CITY OF ALBUQUERQUE

**Re: Lot 12 Block 5 SAD 228
Volcano Cliffs Subdivision Unit 19
6511 Azor Dr. NW
Grading and Drainage Plan
Engineers Stamp Date 8/20/2020 (D10D003H12)
Pad Certification Date 12/16/2020
CO Certification Dated: 7/14/2021**

DRAINAGE AND TRANSPORTATION INFORMATION SHEET (REV 6/2018)

ENGINEER'S SEAL DAVID SOULE P.E. #14522	LOT12 BL5 U19 VOLCANO CLIFFS 6511 AZOR LANE	DRAWN BY DEM
	GRADING AND DRAINAGE PLAN	DATE 8-20-20
	 1608 CENTRAL AVENUE SE SUITE 201 ALBUQUERQUE, NM 87106 (505) 972-0899	LOT 12 BLKS U19 VC REVISED.DWG
		SHEET # C1
		JOB #

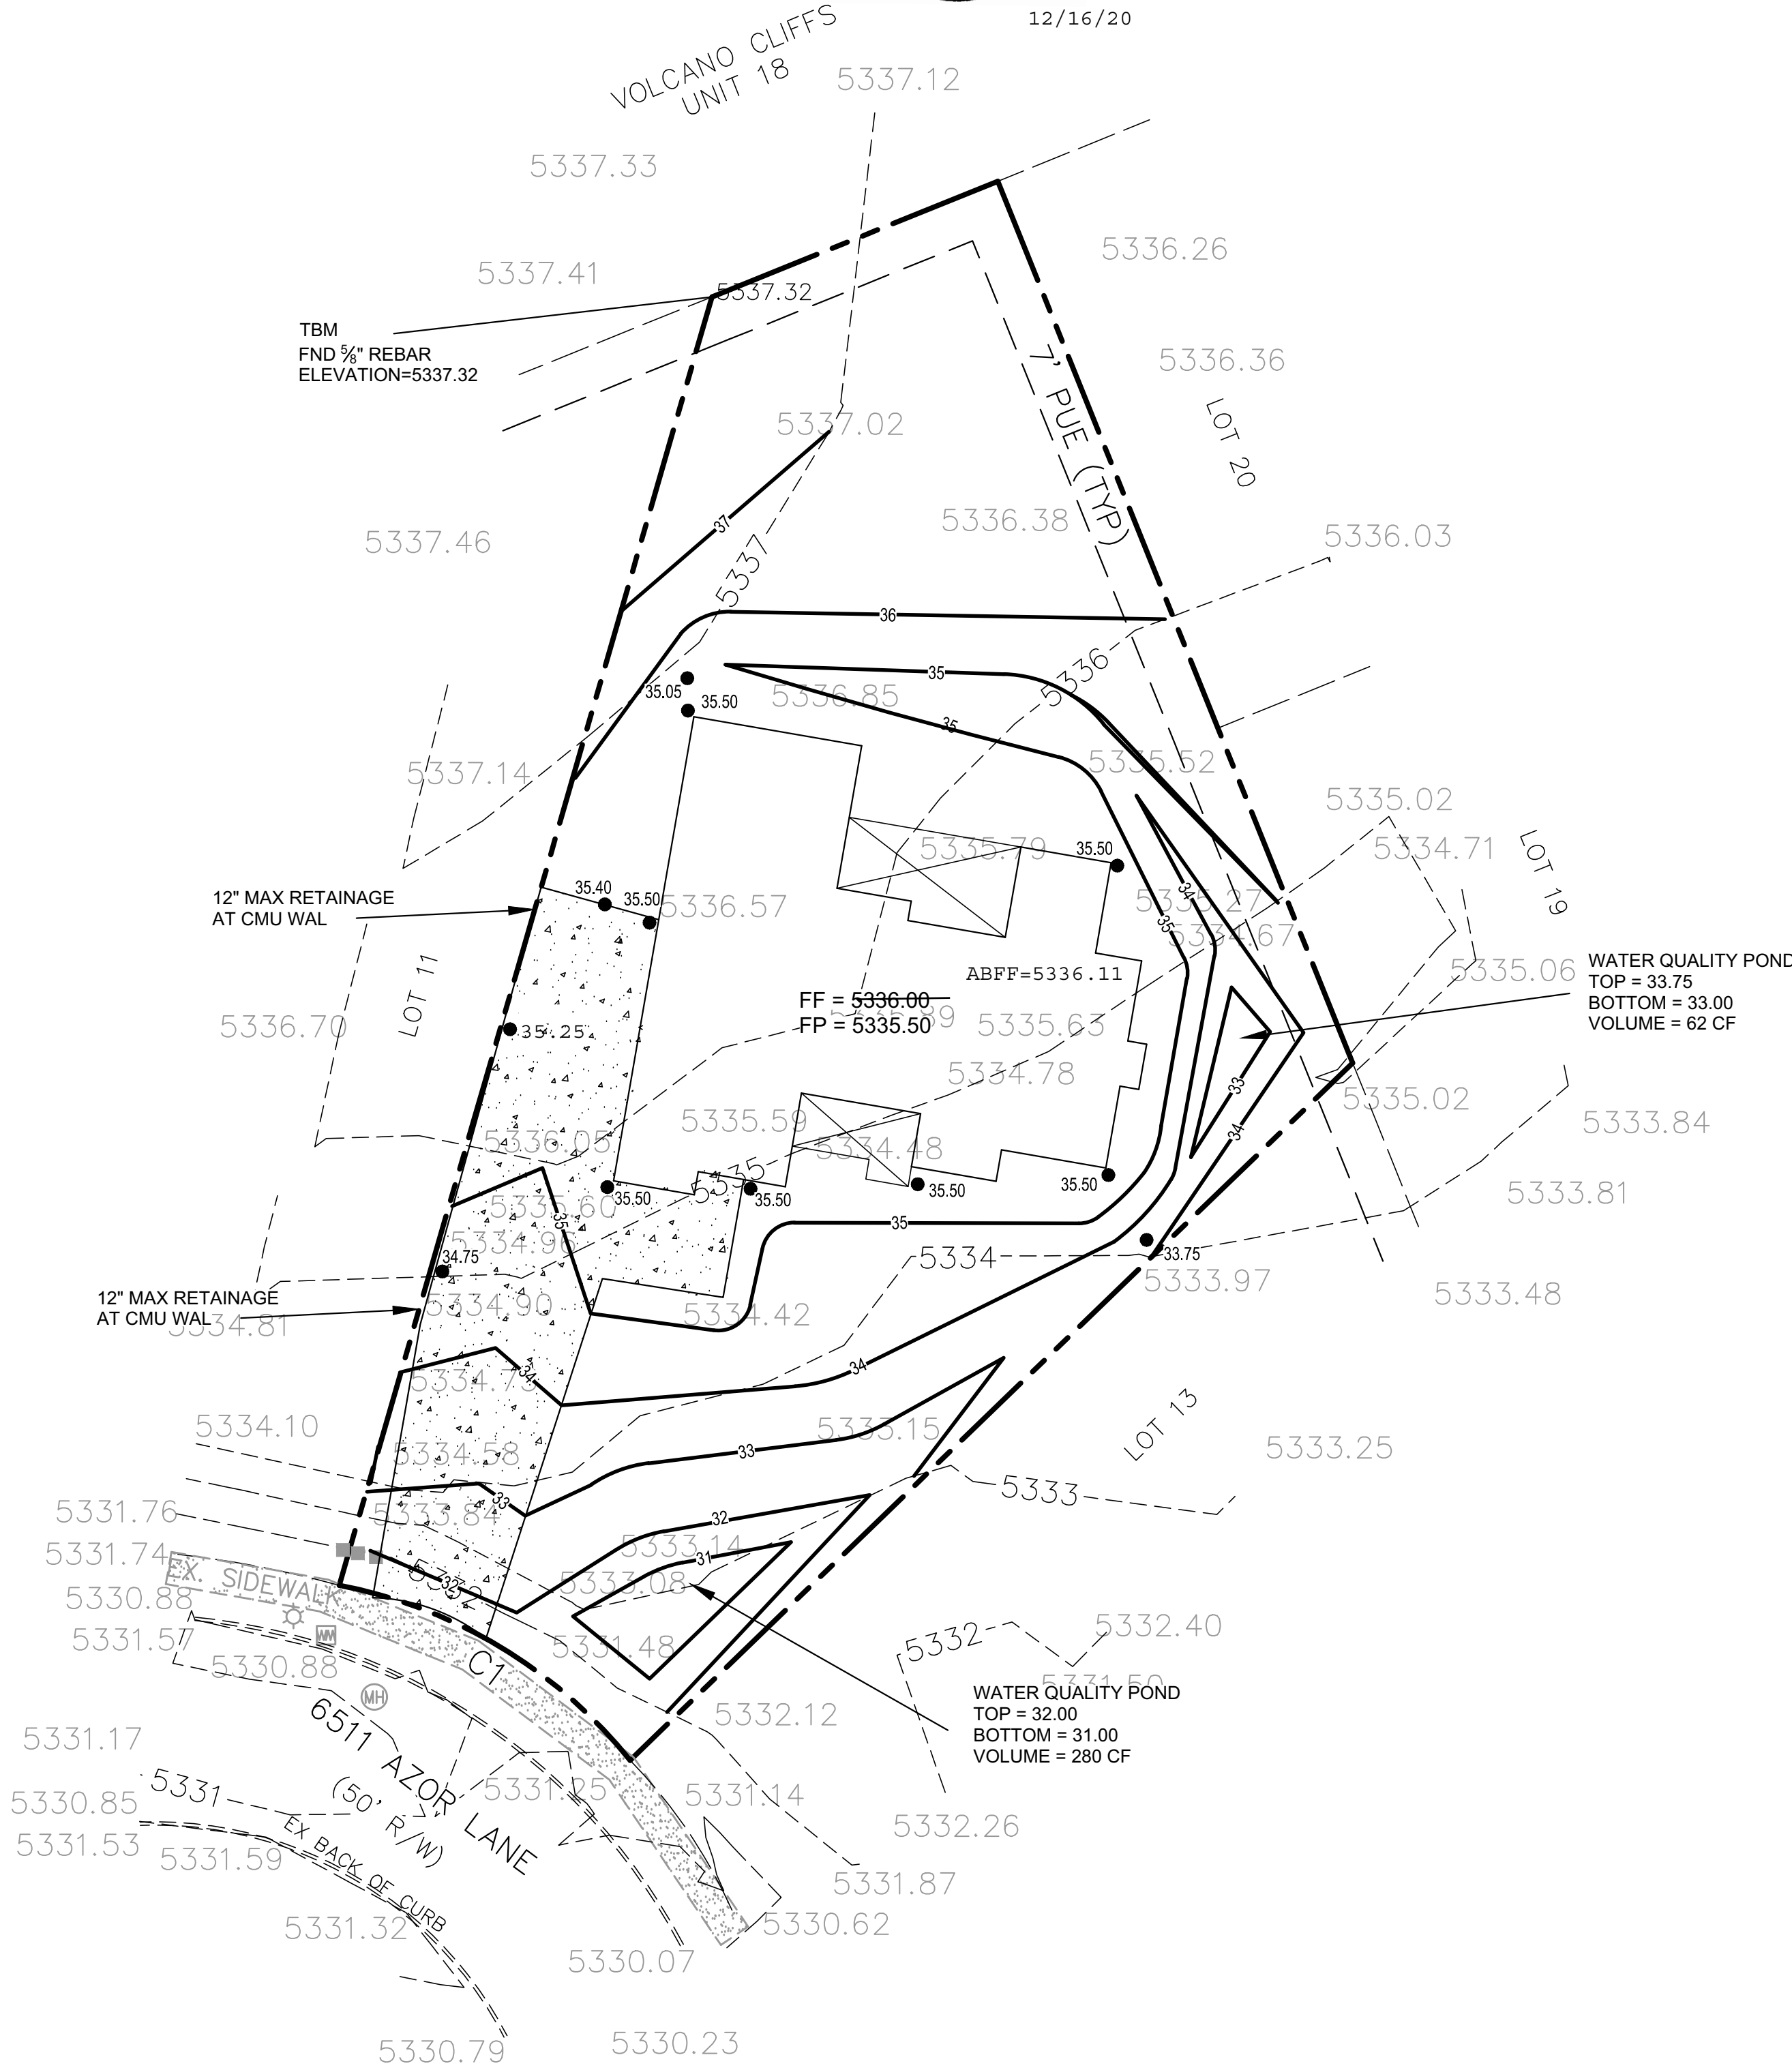
Based on the Certification received on 7/14/2021, the site is acceptable for release of Certificate of Occupancy by Hydrology.
